Re: Hogback Dakota Field
Water Disposal

USG SEC 19 NO. 17

At Chief Hogback Dakota Center Battery Repair Well

Subject: Hogback Dakota Field, Water Disposal

ATTACHMENT M.

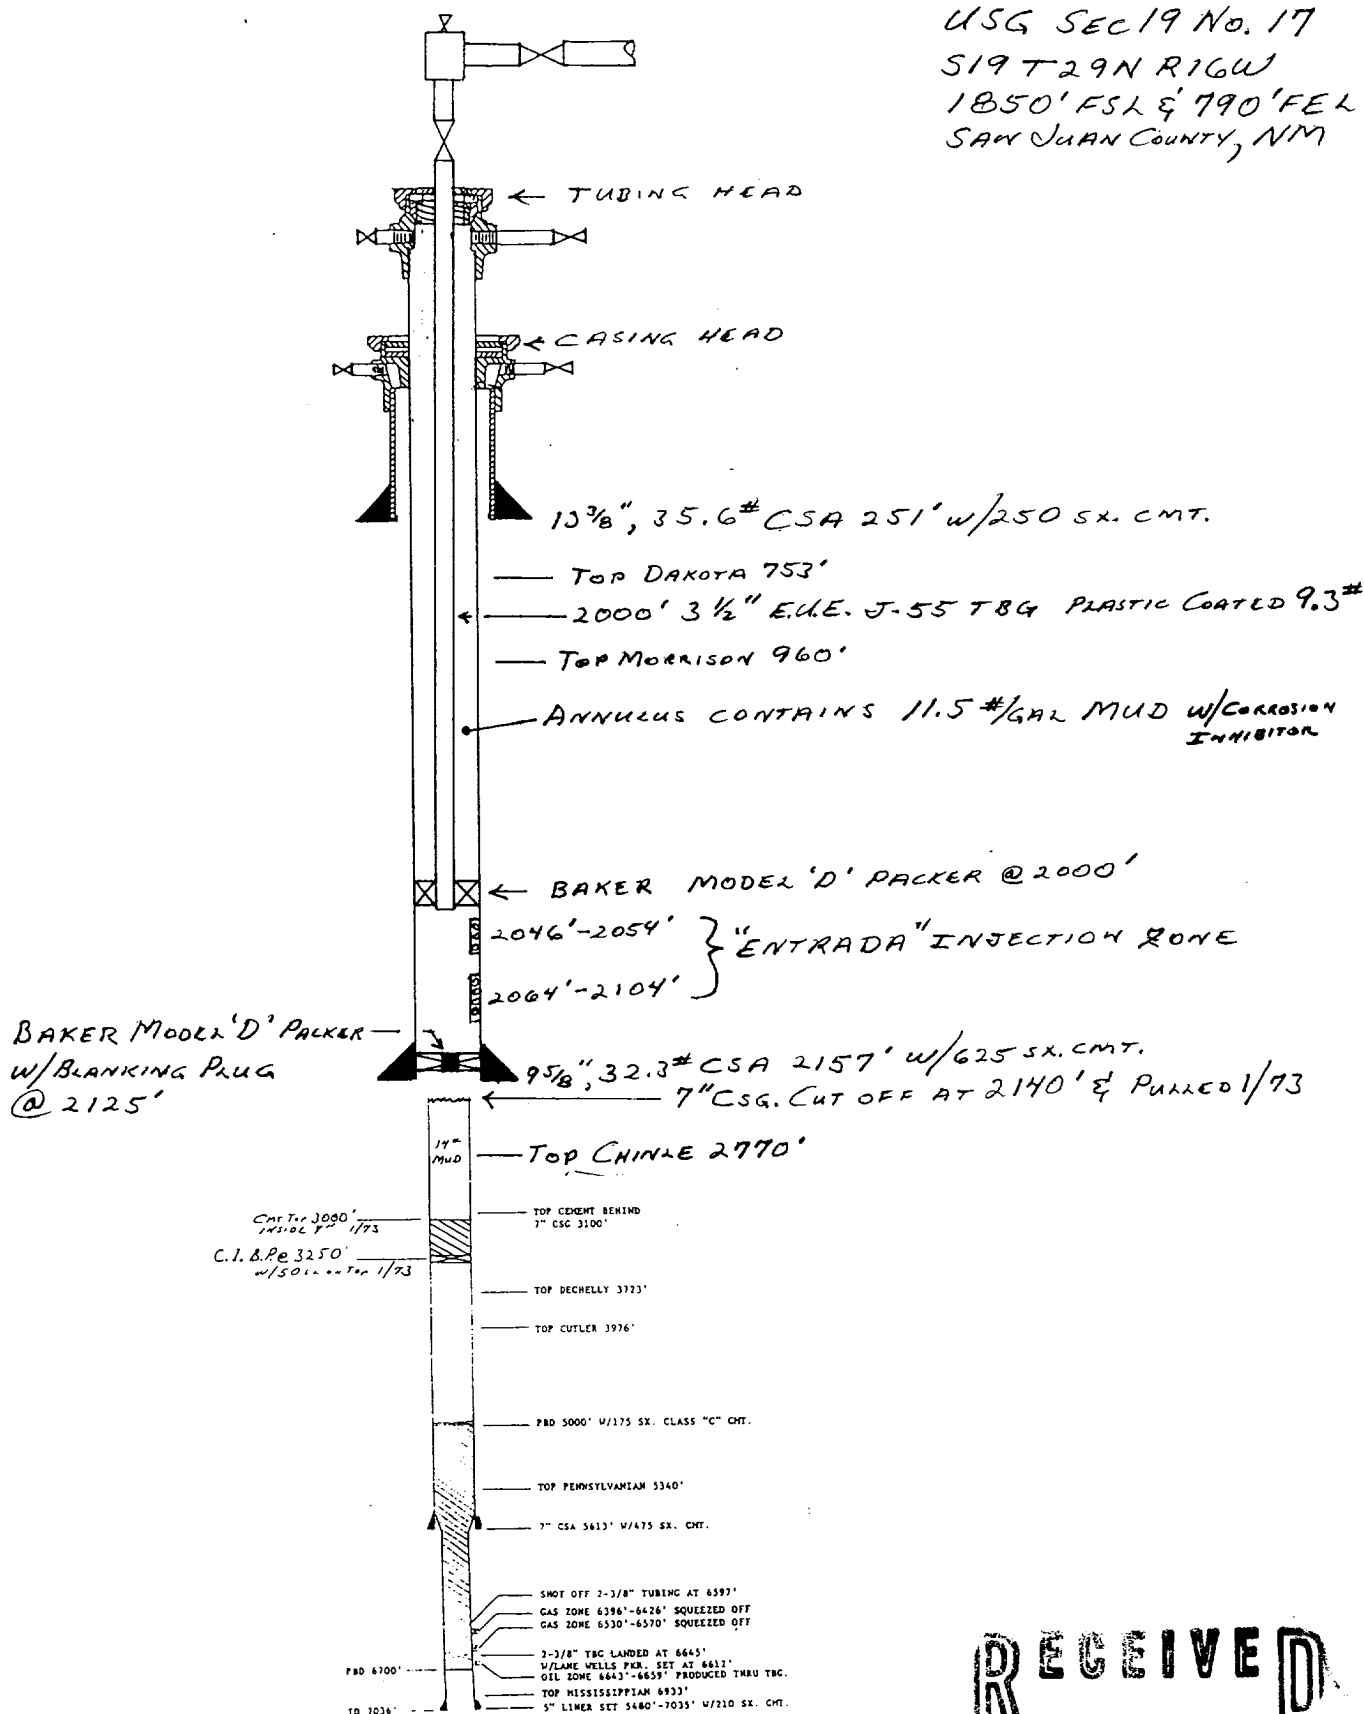
The reason we must fall back on reinjecting the produced water in the Dakota is that our only non-Dakota disposal well, No. 17, which injects into shaley sequences of the Entrada and Chinle formations, has pressured up to the point where our disposal pump can no longer put the water away at the required rates. To illustrate the problem we have attached a copy of the wellbore diagram of Well No. 17 along with the logs which were run across the zones of present interest. Currently water is being injected down the 7" - 9-5/8" casing annulus into either the Entrada or Chinle formations between 2157' and the probable cement top behind the 7" casing at 3100'. Very likely some of our high pressure problems at Well No. 17 results from trying to inject at 5000 BWPD rates in the small clearance between the 7" casing couplings and the 9-5/8" casing I.D.

JAS
We feel that purchasing additional pumping equipment for surface installation would be only a temporary solution, lasting only until the current tight and shaley injection zone increases still further in pressure. Therefore, we recommend that the upper zone of the Entrada be opened in the 60-foot interval of fairly clean, highly porous sandstone from 2045-2105'. This zone is behind the 9-5/8" casing and should have a good cement job. Our recommended procedure is as follows:

- 1) Kill the well.
- 2) Run free point and pull 7" casing.
- 3) Set bridge plug at 2130' in the 9-5/8" casing.
- 4) Perforate the Upper Entrada from 2050'-2100'.
- 5) Breakdown perforations with acid and place on injection test.

Please refer to your letter dated August 22, 1972 concerning the water disposal problem now being faced in the subject field. We agree that the Entrada zone from 2050' to 2100' should be perforated and used for Dakota water disposal. With one exception, we concur with your recommended procedure. In Step No. 2, rather than pulling all recoverable 7" casing, we believe it would be preferable, and more agreeable to the Commission also, to cut off the 7" casing just above the 9-5/8" casing shoe at approximately 2150'. This would still allow you to set a bridge plug below the new perforated zone and yet would maintain some protection of the present open hole zone below the 9-5/8" casing shoe.

Verbal approval from
USGS to perform work at
Hogback No. 17 obtained this
date on condition that
we spot cement plug
3100 feet to 3250 feet in
7" casing.
